REVISIONS			
REV	ECR	DESCRIPTION	DATE	INITIAL	APPROVED
1		LID LENGTHENED BY 1/16 TO ALLOW FOR ADEQUATE CLEARANCE .	3/5/02		
2		MERGED SIX FILES INTO ONE, INSTALLED NEW BOM & REVISION LOG. RE-FORMATTED ENTIRE FILE, ADDED Pg. 1, 6, 7 & 10. ALSO ADDED -68 LID ASSSEMBLY, AND SEVERAL MISSING ITEMS. DELETED -97 FOR TWO MORE -95.	11/7/07	WP	RW
3		ADDED WASH & RINSE LABEL DWG.'S.	12/27/07	WP	RW
4		CH'D HANDLE HOLE POSITION -95 TO MATCH NEW HANDLES. OLD HANDLES ARE UNAVAILABLE.	4/26/10	WP	RW
4A		CH'D BOM INFORMATION FOR -3, -33, & -103 PER B.R.	9/3/10	RJC	RW
4B		REPLACED -9 FROM ARROW #R-162; W/#PK1611 NUT PER R.W.	1/17/12	RJC	RW
5		-81 CH'D HANDLE NOTE FROM 1.870 TO 1.75 MUST MATCH HANDLES -101. CH'D HOLE LOCATIONS FROM .43 TO .375. REPLACED LOWER -95 W/O HOLES WITH 2 -96 TO BOM & DELETED 2 -9595 CH'D HOLE LOCATIONS FROM .435 TO .375 & 2.750 TO 3.00, ADDED MISSING Ø.234 DIM.	2/7/13	RJC	GE
5A		CH'D TITLEBLOCK FROM HELI TECH TO RED BARN. CH'D PLACARD FROM HELI TECH TO DART AREOSPACE.	9/5/13	RJC	RW

RT		
EN	GINE	WASH	ER	
DWG NO.	HT-30	0-CW		REV 6
MAT'L		DRAWN BY:	CLOUGH	
.XX ± .01 AN: X ± .1 1. BREAK ALL SHARP EDG OR .015R 2. DIMENSIONAL LIMITS AP	N INCHES IONS ± 1/8 GLES ±.5° ES .015 x 45°	A

-43 TANK FITTING MODIFICATIONS

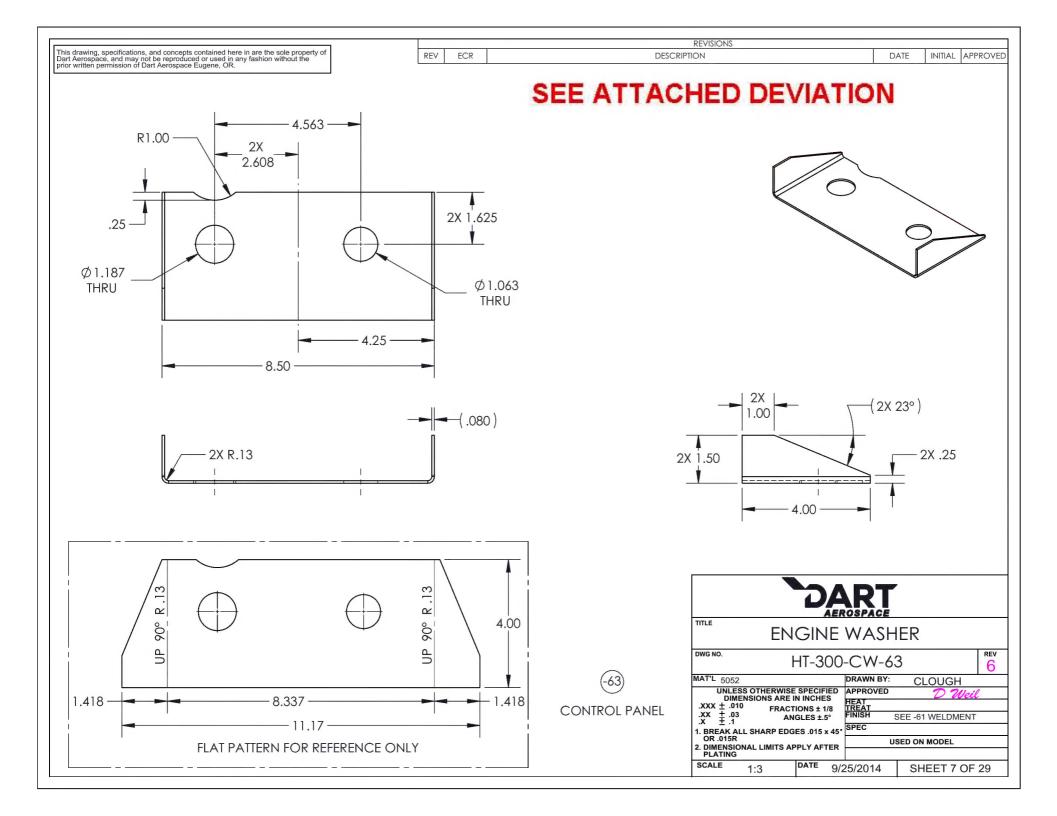
REPLACE SHORT TUBE WITH -51 DIP TUBE IN WASH TANK ONLY INLET SIDE.

LID LATCH MOUNT

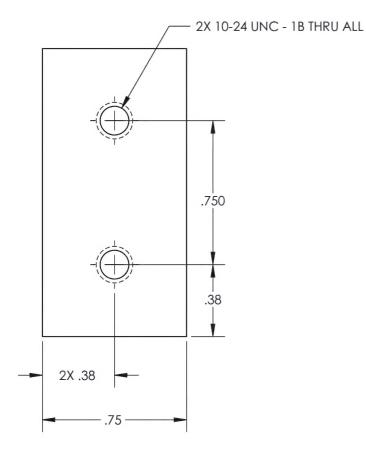
REVISIONS			
REV	ECR	DESCRIPTION	DATE	INITIAL	APPROVED
5A		CH'D PLACARD FROM HELI TECH TO DART AEROSPAC E.	9/5/13	RJC	RW
6	14-0161	-67 ADDED EMAIL TO EMAIL ADDRESS.	10/27/2014	RJC	JAG

CONTROL PANEL PLAQUE

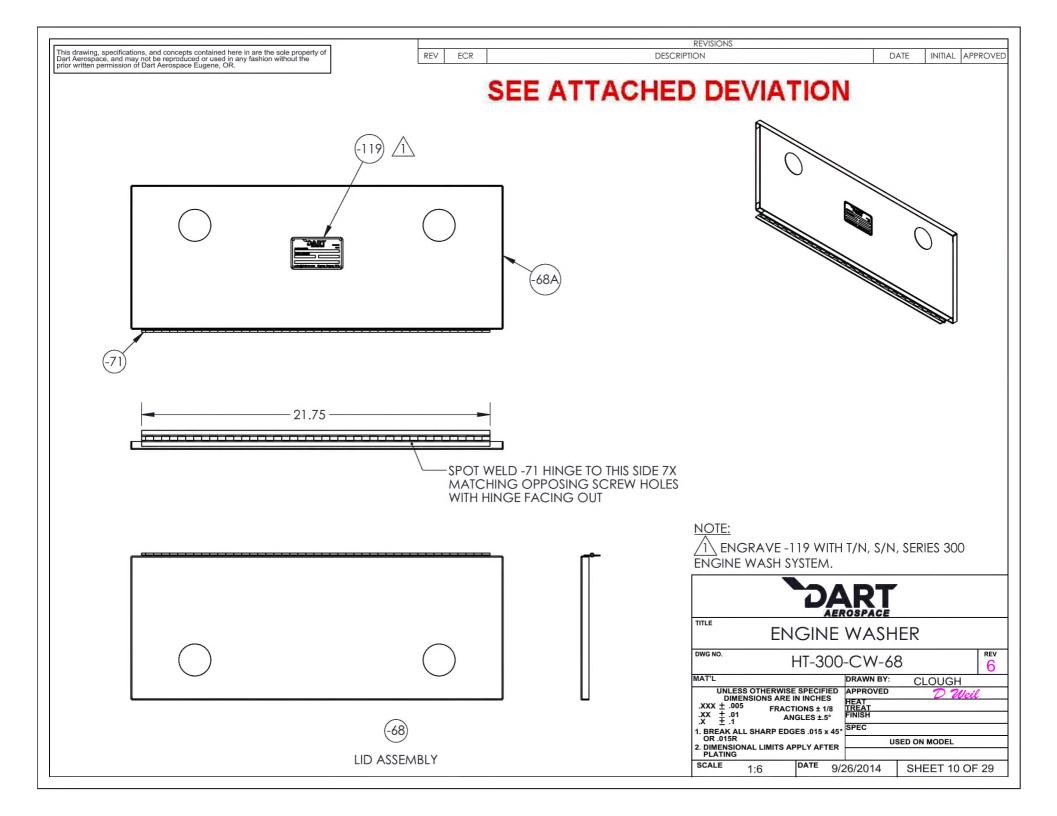
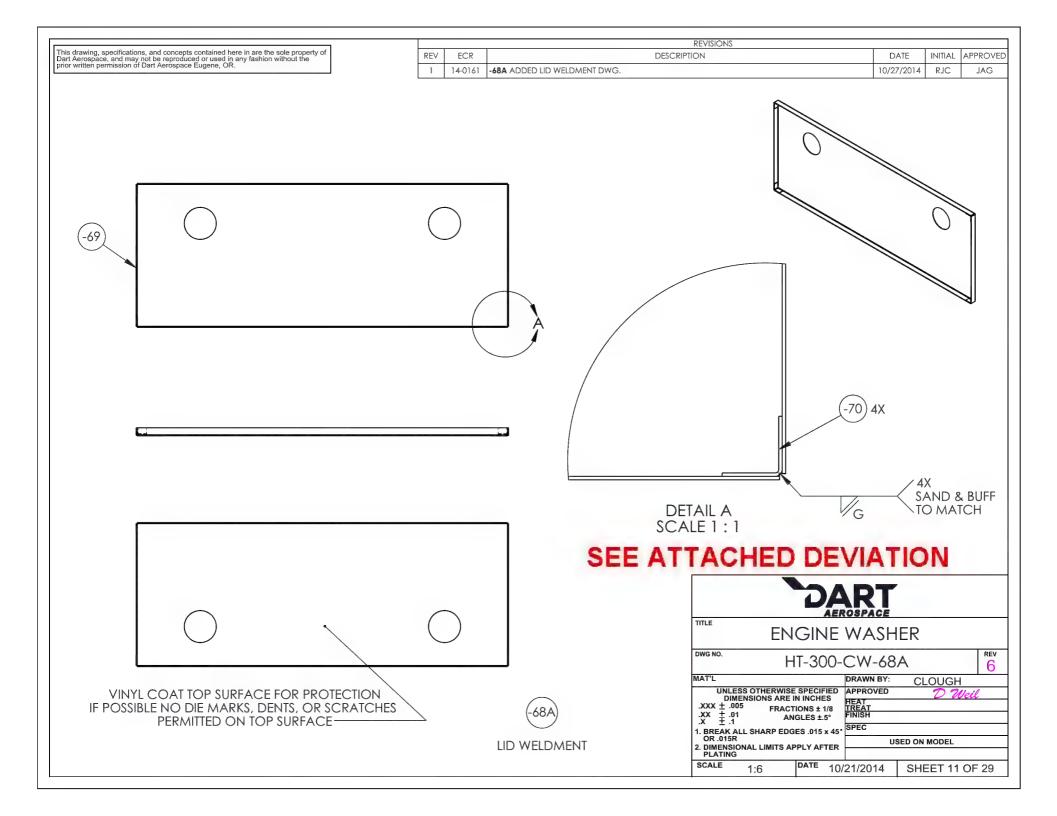
revisions			
REV	ECR	DESCRIPTION	DATE	INITIAL	APPROVED
1		LID LENGTHENED BY 1/16 TO ALLOW FOR ADEQUATE CLEARANCE .	3/5/02		
6	14-0161	-69 CH'D DIM WAS .034 IS .036.	10/27/2014	RJC	JAG

LID

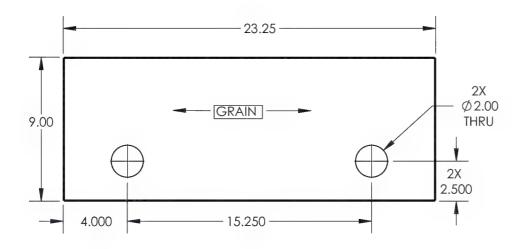
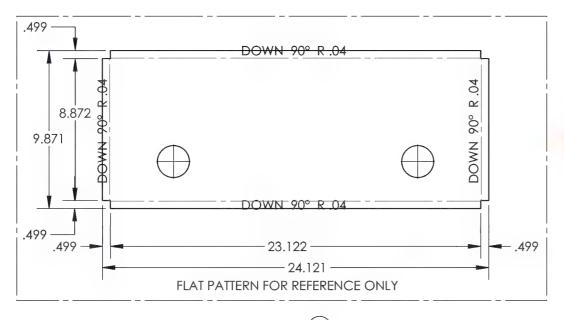
REVISIONS			
REV	ECR	DESCRIPTION	DATE	INITIAL	APPROVED
6	14-0161	-70 CH'D DIM WAS .034 IS .036.	10/27/2014	RJC	JAG

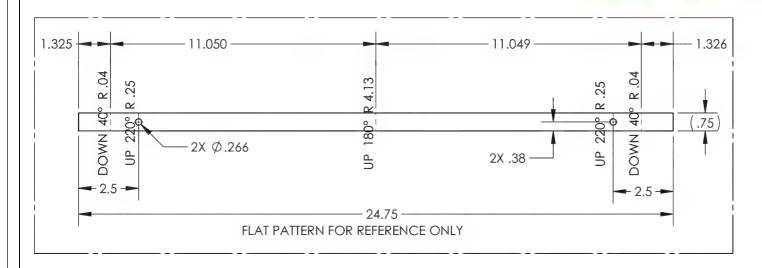
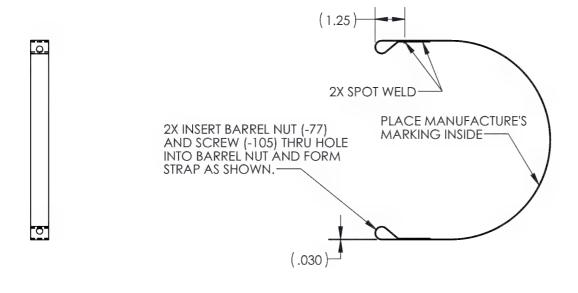
REVISIONS								
REV	ECR	DESCRIPTION	DATE	INITIAL	APPROVED				
6	14-0161	-75 CH'D DESCRIPTION WAS CYLINDER STRAPPING IS CO2 CYLINDER STRAP.	10/27/2014	RJC	JAG

SIDE BARS

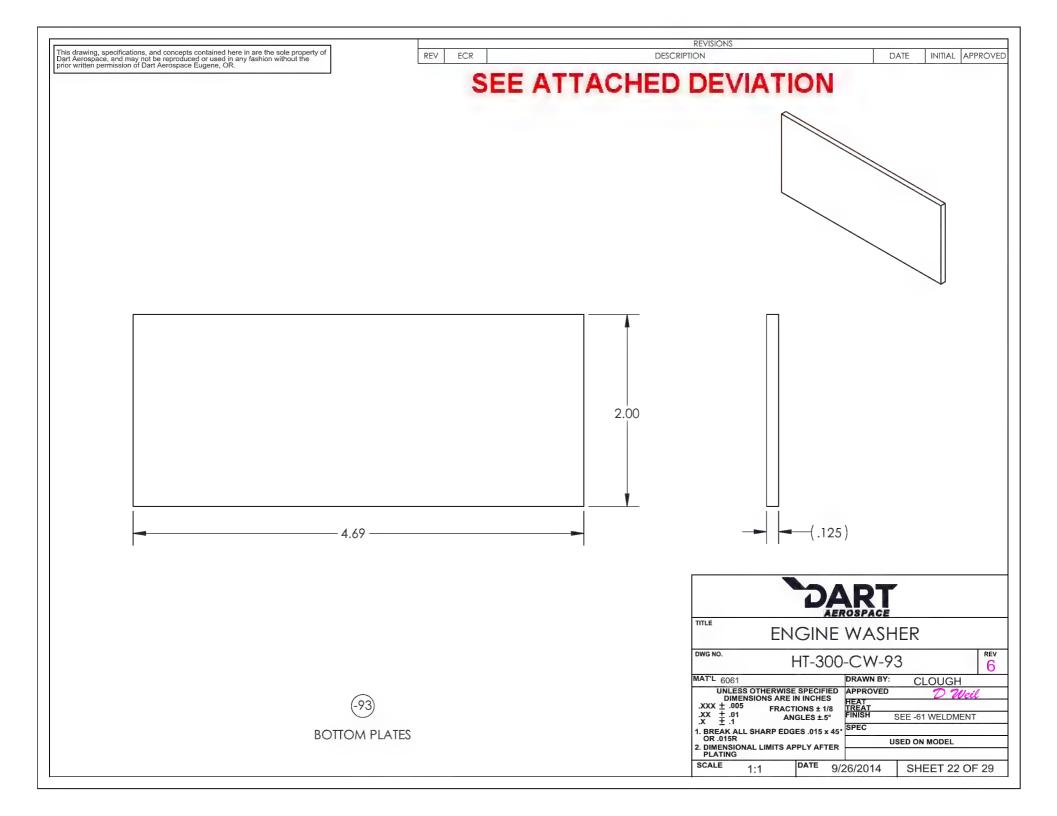
revisions									
REV	ECR	DESCRIPTION	DATE	INITIAL	APPROVED					
5		-96 ADDED SIDE BAR W/O HOLES.	1/31/13	RJC	\$E					
6	6 14-0161 -96 CORRECTED BOM QUANTITY WAS 2 IS 4, PER REV 5.				JAG
